RIDGWAY PLANNING COMMISSION

STAFF REPORT

Request: Sketch Plan
Legal: Town of Ridgway, Block 28 Lots 16-20
Address: 283 N. Cora
Parcel #: 430516209001
Zone: Historic Residential
Applicant: Matt McIsaac
Owner: Matt McIsaac
Initiated By: Shay Coburn, Town Planner
Date: July 28, 2020

NOTES: MC ISAAC SUBDIVISION

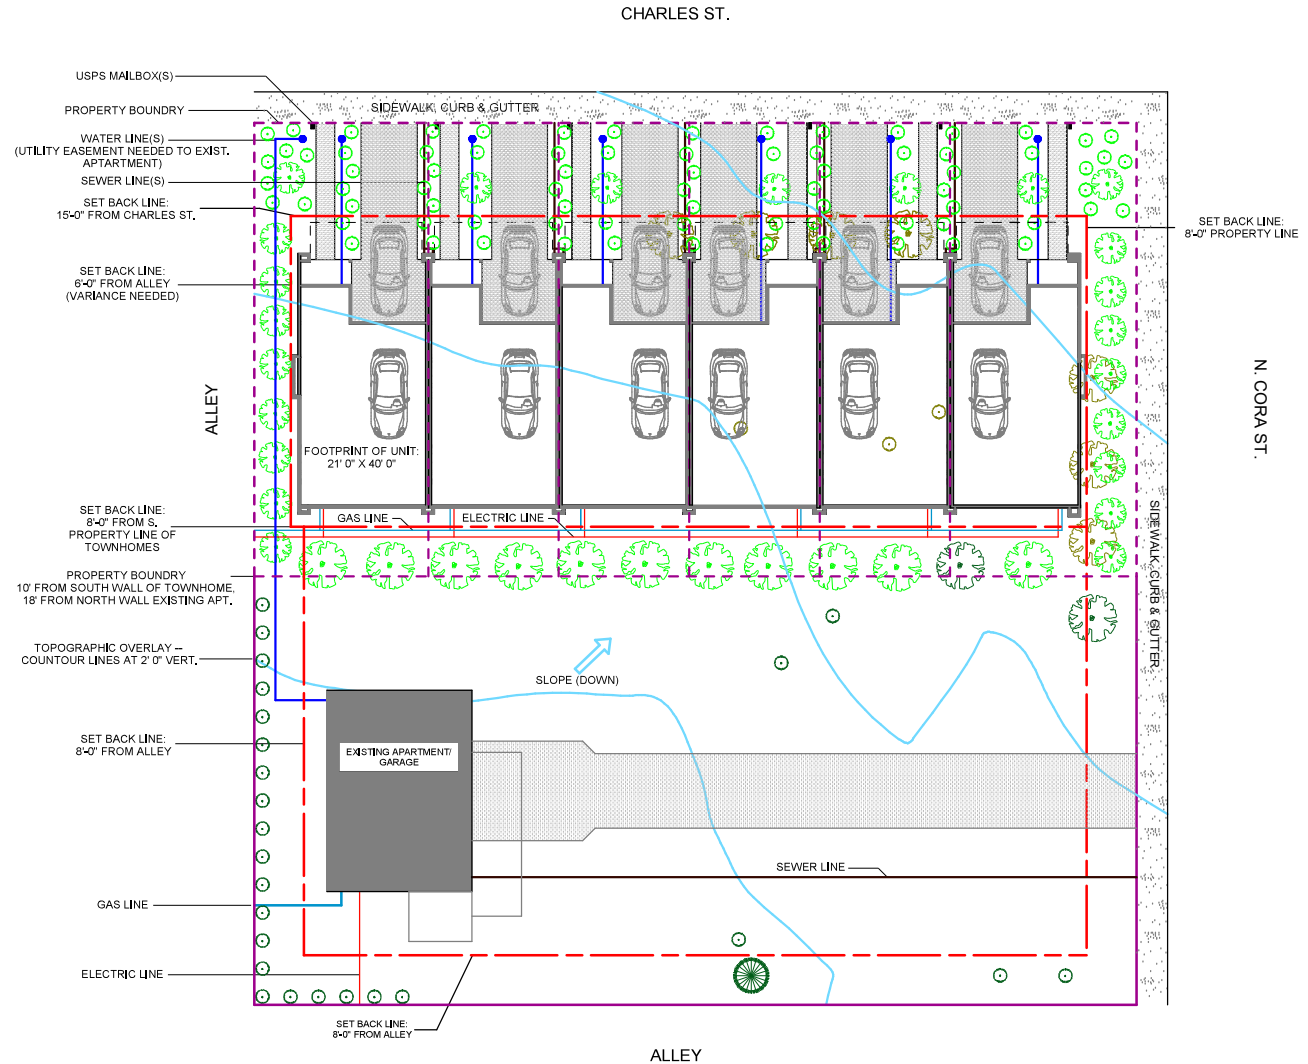
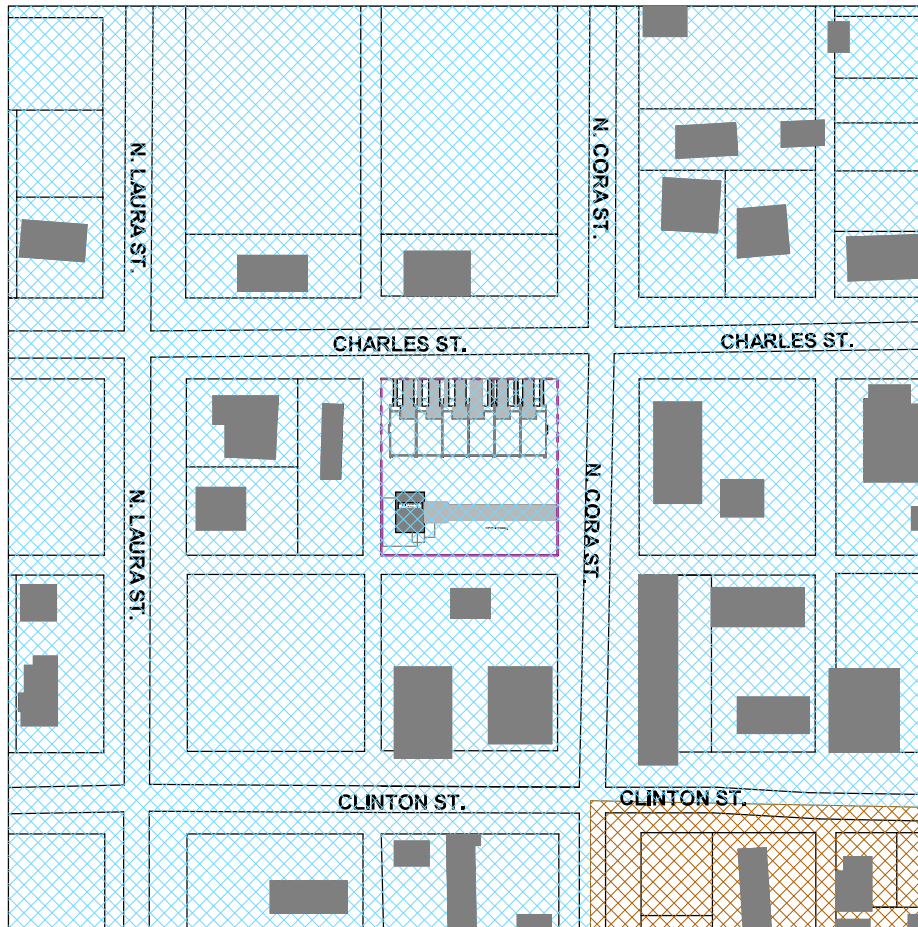
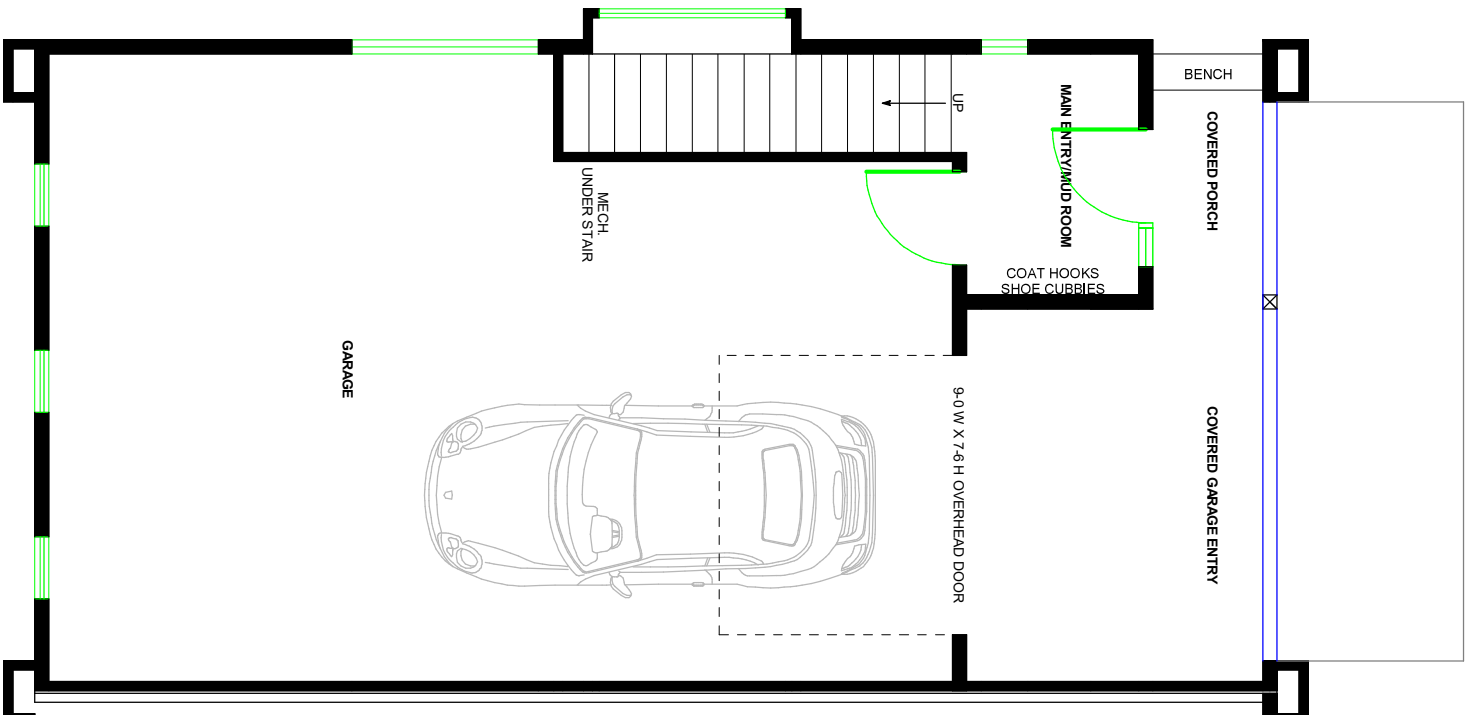
Has the Applicant considered using the (existing) western most water tap to serve the western most townhouse unit and then installing a new line to the existing building from N. Cora? This would eliminate the need for an easement as well as a long water service line under landscaping/trees that could cause long term issues. However, the main in Charles is a larger line and therefore may be better to be tied into.

Sewer service to the townhouses will need to be reconciled. The plans appear to show 5 lines but staff understood the plan to be for 2 units to share a line, meaning 3 lines total for the 6 units. If the driveways are to be gravel it may be better to put the service lines under the driveways. If they are to be hard surfaced then having them in the landscape area may be better.

Please color future utility plans to the UNCC colors for easier review.

Existing trees are identified on the site plan, seven will be removed, two will remain. Existing utilities are on the site plan.

There are not many existing natural features on this site. Staff is unsure how this plan works with views, existing drainage, and other existing conditions.
